From: **Technical Support** technical@thermoguard.co.uk
Subject: Re: MJM - Fire Doors
Date: 19 November 2020 at 15:10
To: Candice Moore candice@citizensdesignbureau.net

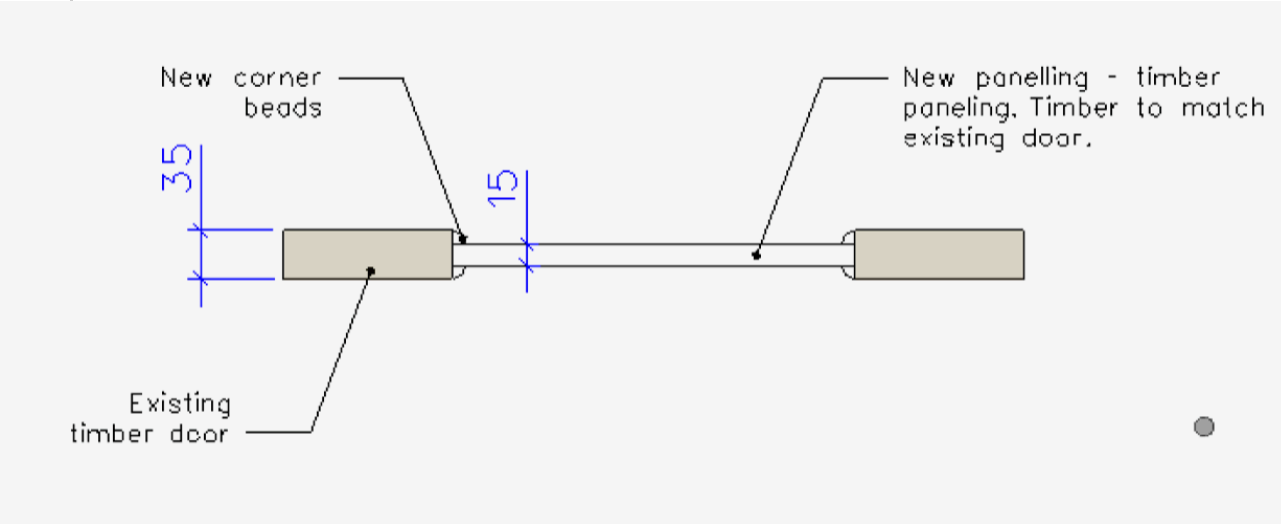
> Thanks, would upgrading it as below be acceptable:

> Just checking our doors of 45mm with 13mm panels okay?
>
> Thanks,
>
> Candice Moore
>
> citizens **design** bureau
>
> 02030959732
> www.citizensdesignbureau.net
>
> Ground floor Units 01 & 03
> 6 Westgate Street
> E8 3RN
>
> Please only print this if you absolutely have to…!
>
> Confidentiality and Disclaimer. This email and its attachments are intended for the addressee only and may be confidential or the subject of legal privilege. If this email and its attachments have come to you in error you must take no action based on them, nor must you copy them, distribute them or show them to anyone. Please contact the sender to notify them of the error. This email and any attached files have been scanned for the presence of computer viruses. However, you are advised that you open any attachments at your own risk.
>
> On 19 Nov 2020, at 13:00, Technical Support <technical@thermoguard.co.uk> wrote:
>
> Sorry Candice,

Hi Candice,
If approved by your building inspector then yes.
